SERVICE BULLETIN

from: TRIO-KENWOOD COMMUNICATIONS, INC.

SUBJECT: SERVICE NOTES ON TS-820

DATE 10-25-77

SUBJECT: Microphone input attenuator for TS-820 DATE 2/16/77

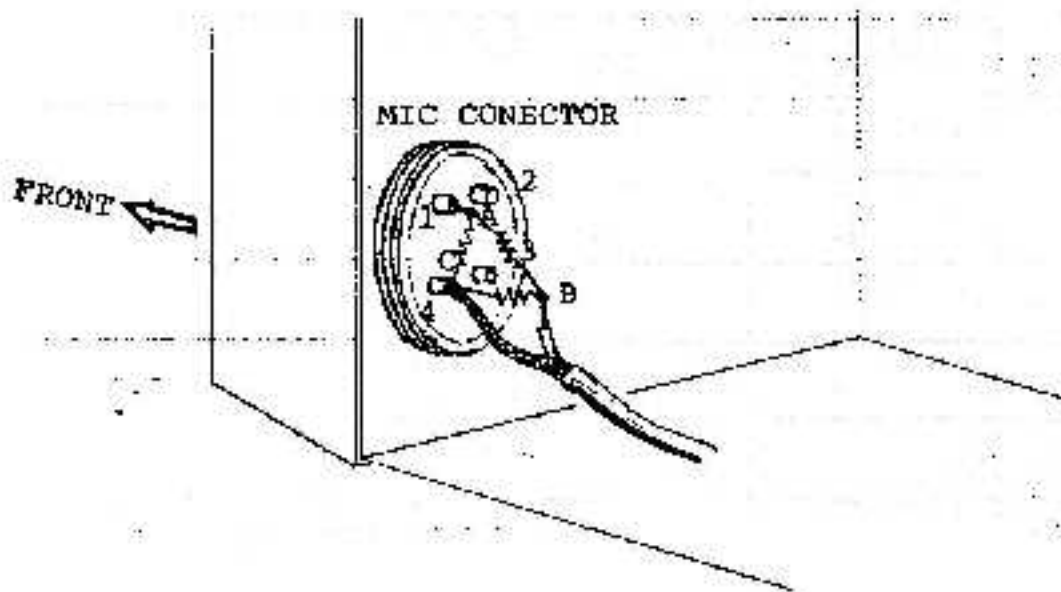
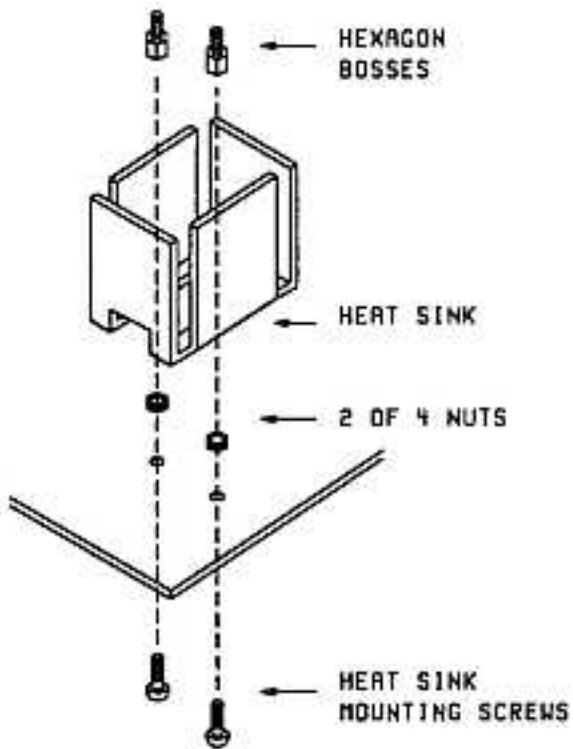
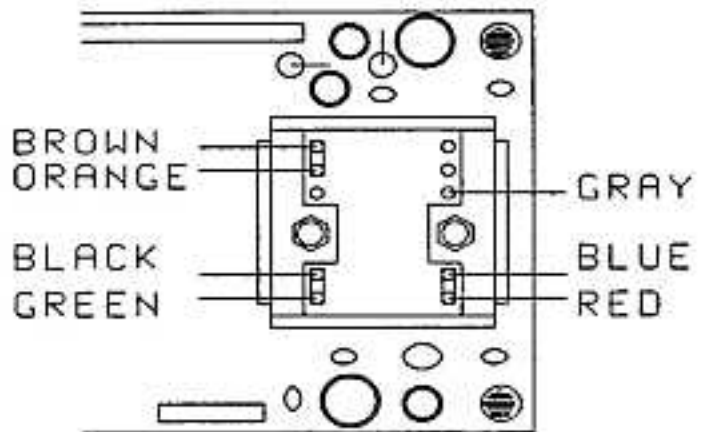
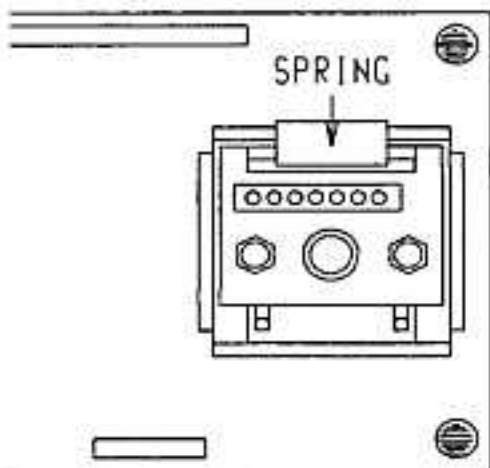
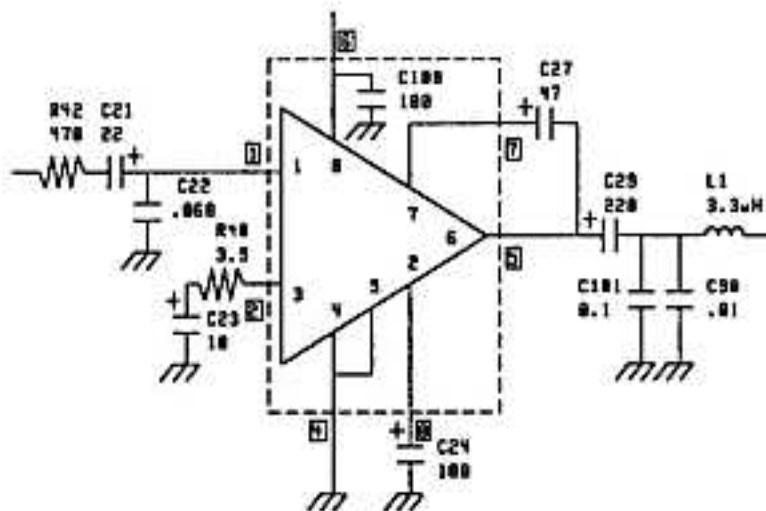
When using a high output microphone (i.e. Shure 444), it is very likely that there will be distortion of the transmitted audio if the processor is used. The reason the distortion occurs is because the processor is between the first microphone amplifier and the microphone gain control. The installation of one of the attenuators shown below will reduce the microphone input to a level that will not cause RF speech processor distortion. The attenuator figures are approximate.

SUBJECT: DS-2 Replaces DS-1A DC-DC Converter

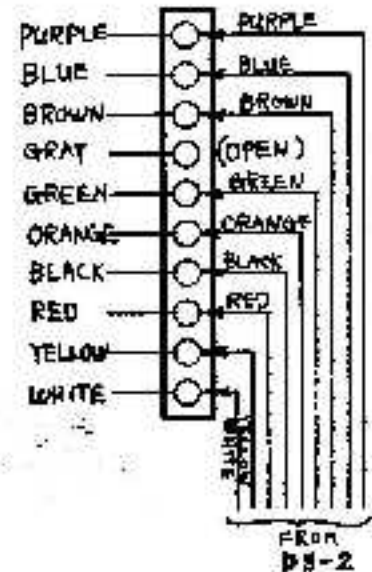
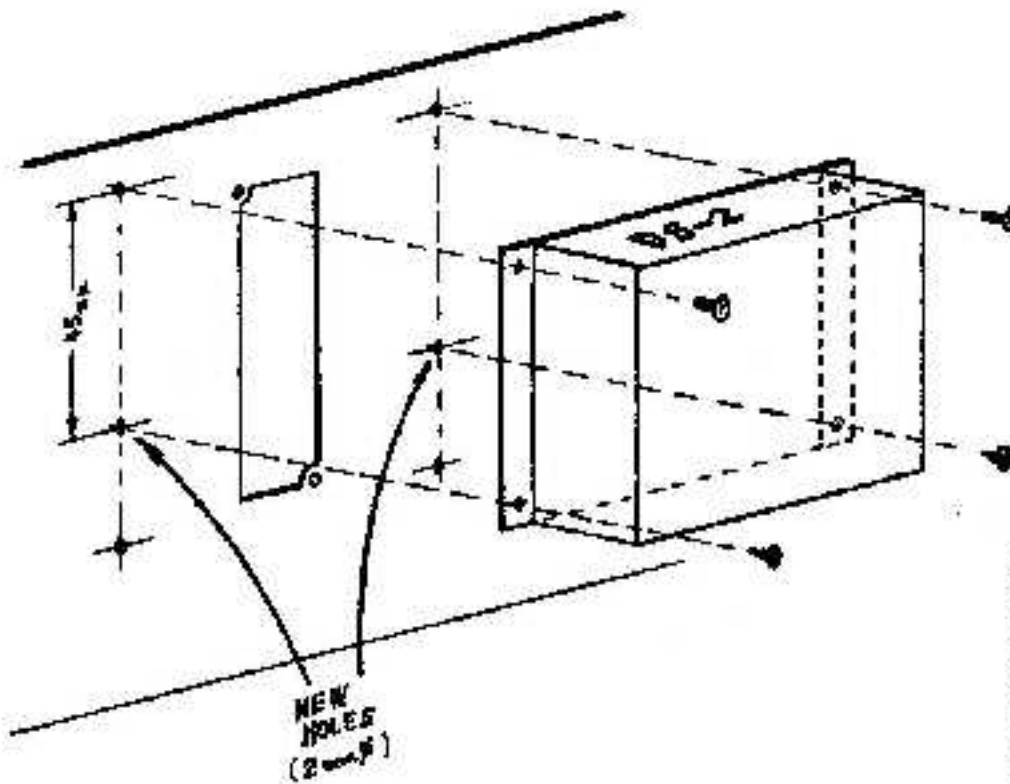
The DS-1A DC-DC converter for the TS-820 series and TS-520/S has been replaced by a new model, the DS-2. Wiring color code is the same. Physical size is smaller. Two additional mounting holes must be drilled in the transceiver rear panel.

SUBJECT: TS-820 RIT Modification

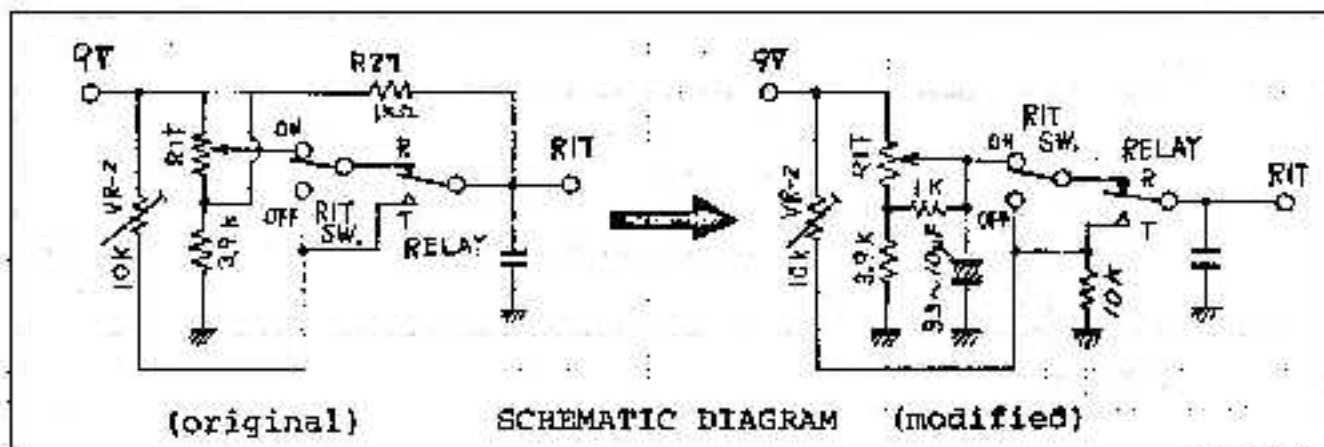
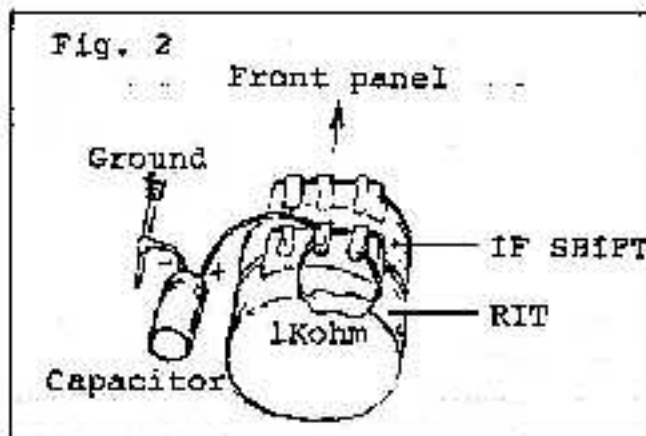
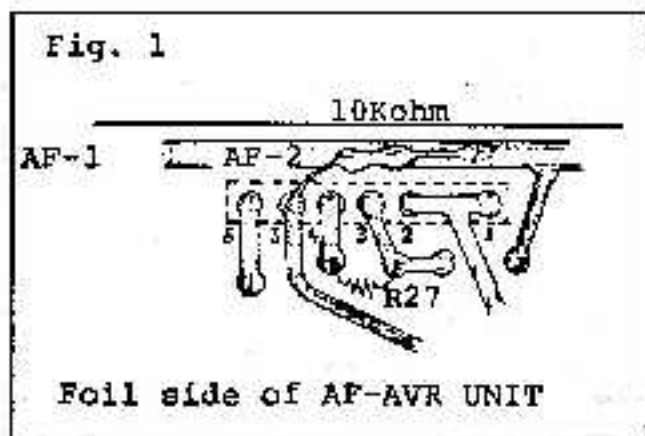
We have had a few reports of the TS-820 RIT tuning being "rubbery". The following information will solve this.

1. Remove resistor R27 (1Kohm) on AF-AVR UNIT (X49-1080-00).
2. Install a 10Kohm resistor on foil side of AF-AVR UNIT --- see Figure 1.
3. Install a 1Kohm resistor on RIT control --- see Figure 2.
4. Install a capacitor (3.3 μ F-10 μ F) between RIT control and ground --- see Figure 2.
5. Adjust VR-2 on AF-AVR UNIT (X49-1080-00) for the same frequency as the center position of the RIT control.
